**3.10 TRANSPORTATION****Comment 70: Dan Broedel, Program Director, Midstate Regional Emergency Medical Services Council, Public Hearing, 12/6/18:**

**Figure 28. Five Minute Walking Radius.**

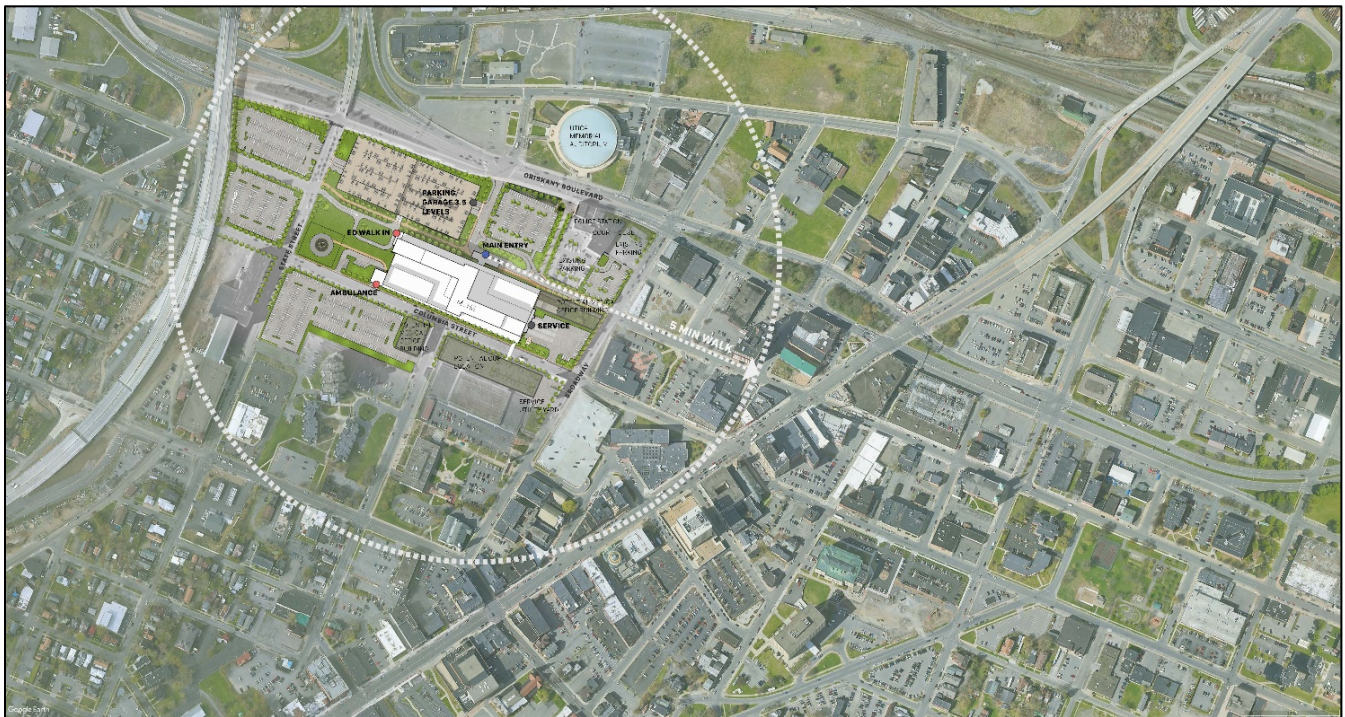
**Creating a more Walkable Utica/Downtown:** While I appreciate the planning process for the hospital *building* itself (“*from the inside-out*”, the building taking shape according to the needs of the individual departments within), The *campus* plan for the hospital as presented lacks street level tenants/amenities sufficient to create a more walkable Utica/Downtown. Specifically, the **Columbia/Lafayette east/west corridor** of the proposed hospital campus, linking Genesee Street and West Utica – and more specifically, the two blocks between Broadway and State Street - are not sufficiently “walkable” as there is little or no walker experience/interaction along the way.

As illustrated on Figure 28, the Project is located in an area, which is within a 5-minute walk of the City’s urban center and other points of interest.

**Figure 31. Proposed Traffic Mitigation**

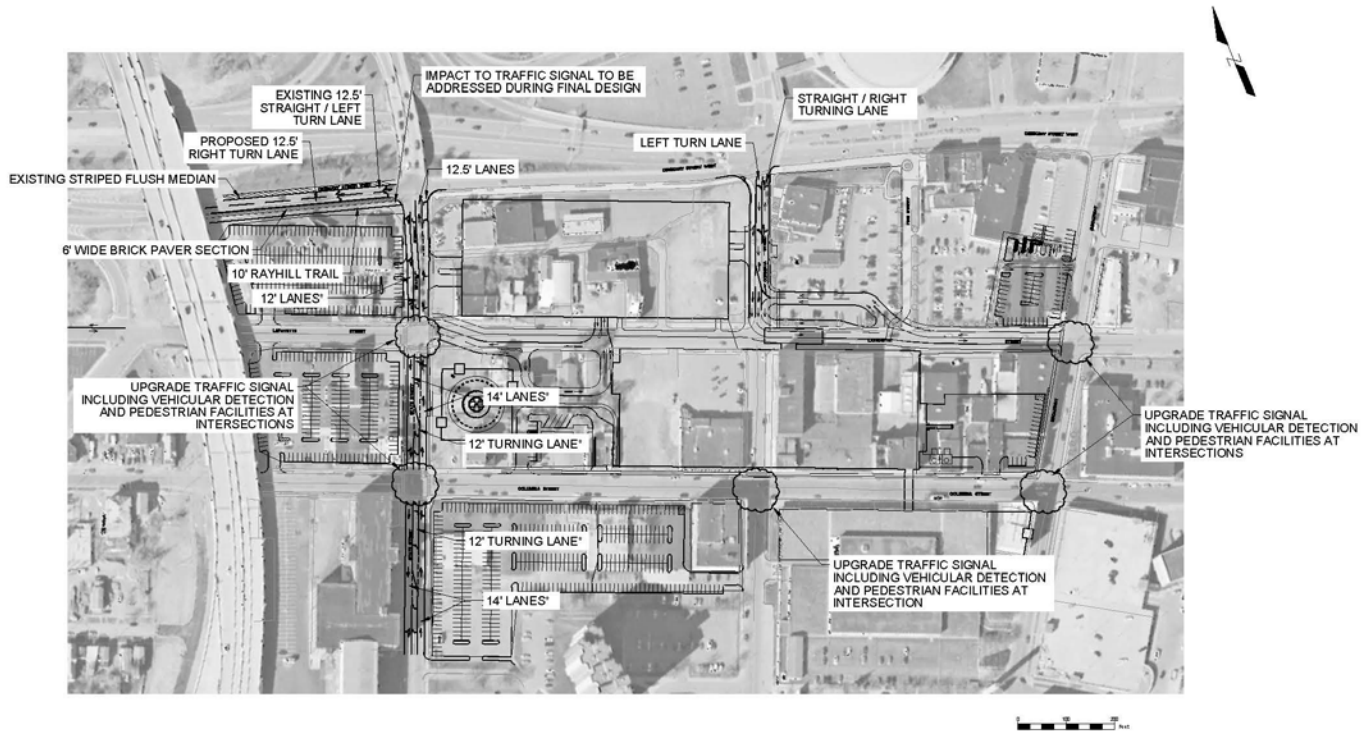
Overall, the Traffic Impact Study relied solely on traffic signal timing changes to mitigate the effects of the increased traffic volumes associated with the development. In addition, some of the proposed timing changes result in level of service drops to mainline NY 5S. Signal upgrades and geometry changes will be required to achieve acceptable level of service.

An addendum to the TIS is provided as Appendix D to this FEIS Responsiveness Summary. The Addendum addresses the NYSDOT's comment regarding traffic operations and potential mitigation measures. As requested by the NYSDOT, a separate analysis was conducted to take a conservative look at recommended mitigation measures on NYS Route 5S, specifically. The Addendum notes all recommended mitigation measures for the entire study area and is summarized below. Proposed mitigation and locations are also illustrated on Figure 31.

- Ensure adequate pedestrian facilities are available in the vicinity of the Project Site including locations that are expected to have increased pedestrian activity as a result of the proposed Project as shown on the mitigation plan (Figure 31)

- Upgrade or replace traffic signals to add detection, actuation, coordination, and pedestrian accommodations at the following locations:
  - » 2-State Street & NYS Routes 5/8/12 off/on-ramp

- » 3-State Street & Lafayette Street
  - » 4-State Street & Columbia Street
  - » 6-Cornelia Street & NYS Route 5S/Oriskany Street
  - » 8-Cornelia Street & Columbia Street

- » 10-NYS Route 5S/Oriskany Street & Broadway
  - » 11-Broadway & Lafayette Street
  - » 12-Broadway & Columbia Street
  - » 20/21-NYS Route 5S/Oriskany Street & Genesee Street

- Optimize signal timings at the following intersections (upgrade/update equipment as needed):
  - » The coordinated system which includes intersections 2 – State Street & On/Off-Ramps, 3 – State Street & Lafayette Street/Emergency Department Access (PM), and 4 – State Street & Columbia Street

- » The coordinated system which includes the intersections of 6 - NYS Route 5S (Oriskany Street) & Cornelia Street, 10 – NYS Route 5S (Oriskany Street) & Broadway, and 20/21 – NYS Route 5S (Oriskany Street) & Genesee Street

- Construct a dedicated right turn lane on the eastbound approach to intersection 2 – State Street & On/Off-Ramps
- Provide a center two-way left-turn lane on State Street from intersection 2 – State Street & On/Off-Ramps to just south of intersection 4 – State Street & Columbia Street

- Construct a dedicated left turn lane on the northbound approach to intersection 6 – NYS Route 5S (Oriskany Street) & Cornelia Street
